<b>EASA</b>	<b>NOTIFICATION OF A PROPOSAL TO ISSUE AN AIRWORTHINESS DIRECTIVE</b>
	<p><b>PAD No.: 13-118R1</b></p> <p><b>Date: 23 September 2013</b></p> <p>Note: This Proposed Airworthiness Directive (PAD) is issued by EASA, acting in accordance with Regulation (EC) No 216/2008 on behalf of the European Community, its Member States and of the European third countries that participate in the activities of EASA under Article 66 of that Regulation.</p>
<p>In accordance with the EASA Continuing Airworthiness Procedures, the Executive Director is proposing the issuance of an EASA Airworthiness Directive (AD), applicable to the aeronautical product(s) identified below. All interested persons may send their comments, referencing the PAD Number above, to the e-mail address specified in the 'Remarks' section, prior to the consultation closing date indicated.</p>	
<p><b>Type Approval Holder's Name :</b></p> <p>AIRBUS</p>	<p><b>Type/Model designation(s) :</b></p> <p>A300, A300-600, A300-600ST and A310 aeroplanes</p>

<p>TCDS Numbers : France No. 145 and EASA.A.014</p>	
<p>Foreign AD : None</p>	
<p>Supersedure : This AD supersedes EASA AD 2011-0006 dated 17 January 2011.</p>	
<b>ATA 29</b>	<b>

**Appendix 1**

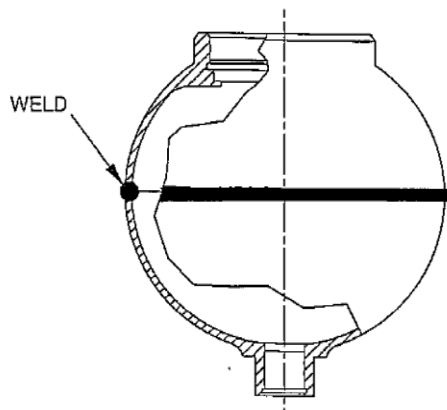
**HYDRAULIC ACCUMULATOR** : designed with 4 parts and 3 welds

**OLD DESIGN**

**HYDRAULIC ACCUMULATOR** : designed with 2 parts and 1 weld

**NEW DESIGN**
